CHANDRA K. SACHETI, M.D., LLC  
561 TALCOTTVILLE ROAD  
VERNON, CONNECTICUT 06066  
TELEPHONE: (860) 871-2018

06 – Jan – 10

Please note, we are requesting a change in areas of use of radioactive material under our byproduct material license #06-30781-01. Attached is a copy of our new floor plan, which indicates a change of location of the nuclear lab and a change in location of the stress lab as well. Both labs will be within the existing building on the same floor.

**1** **SCHEMATIC FI**  
 SK-C SCALE: 3/16"=1'-0"

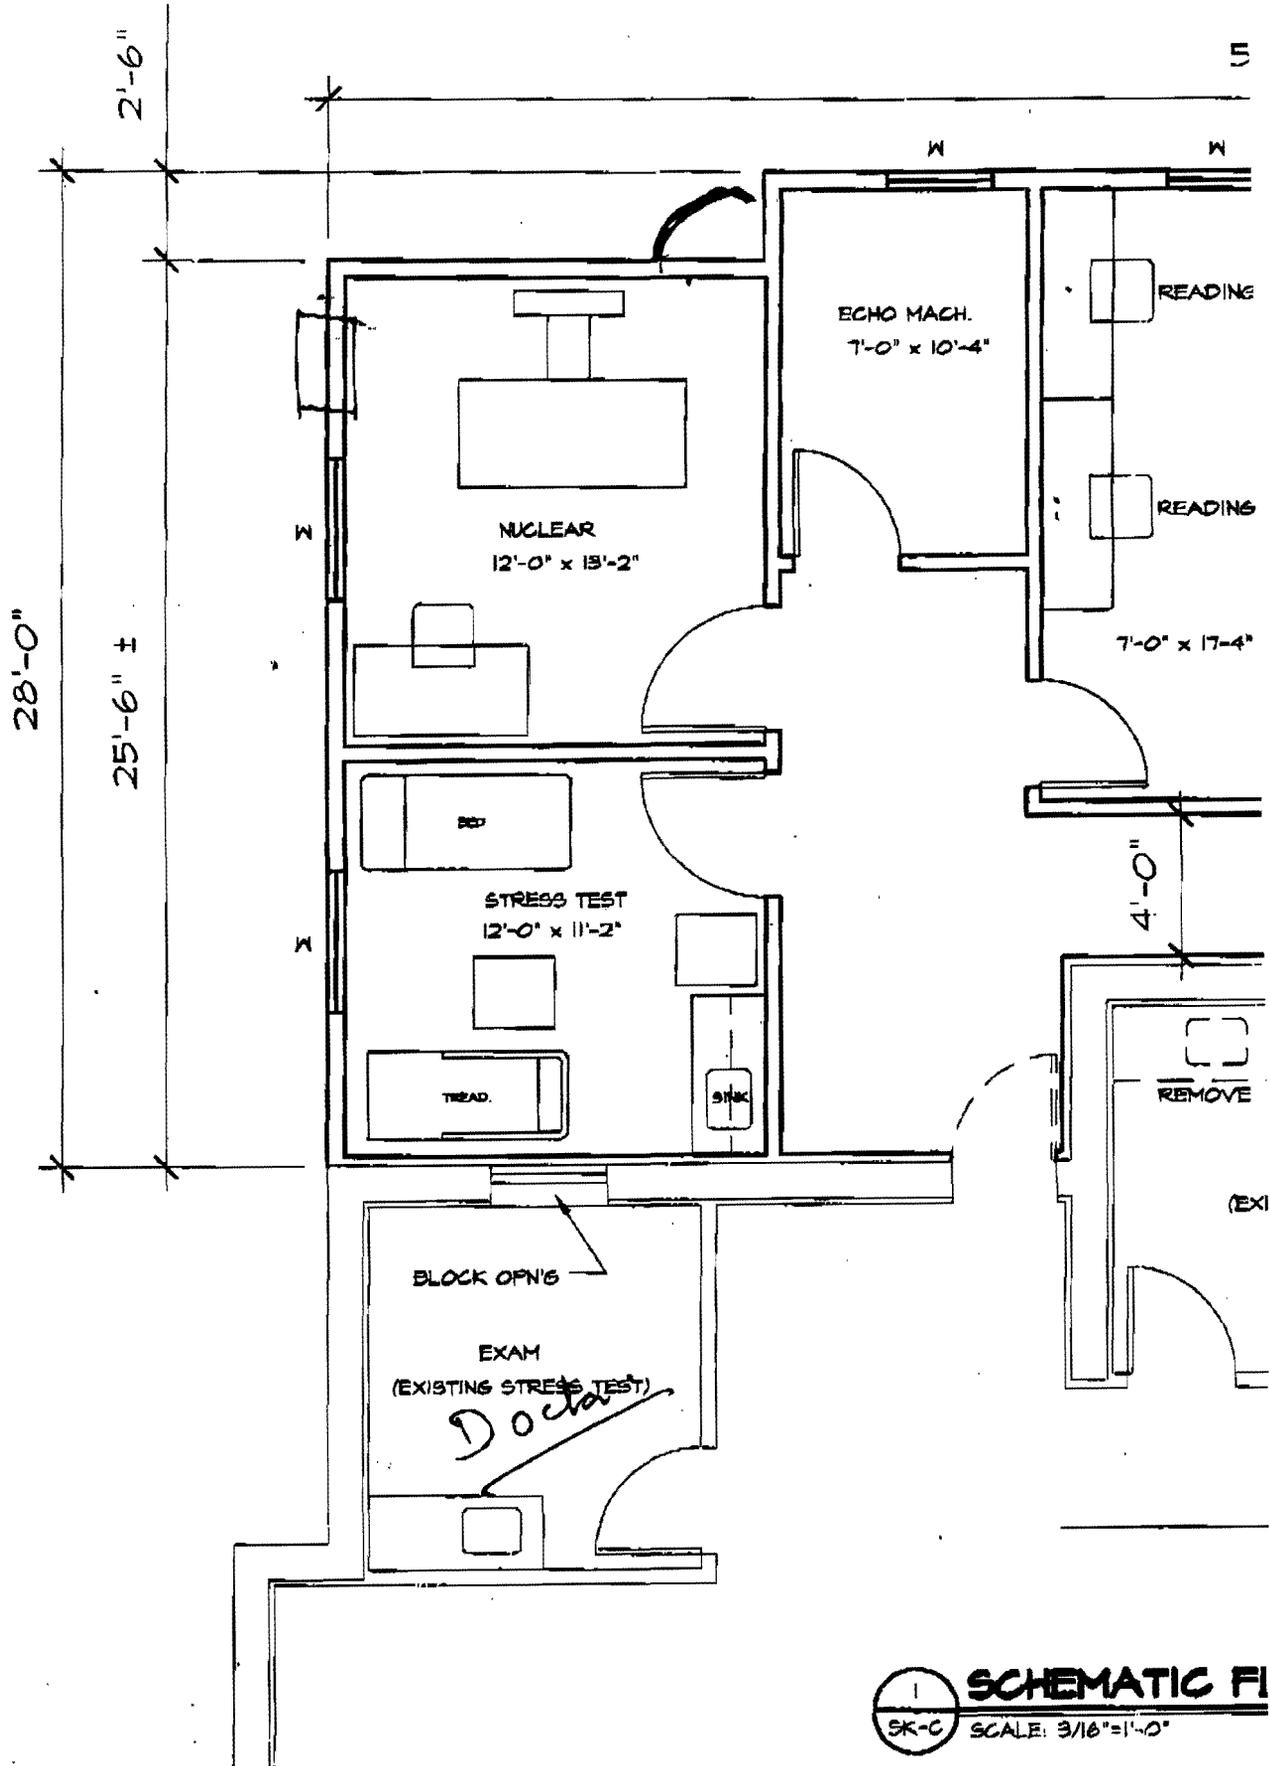
All ALARA tools presently being used will be used in the same fashion in the new location, ie L – Block, lead shielding etc.
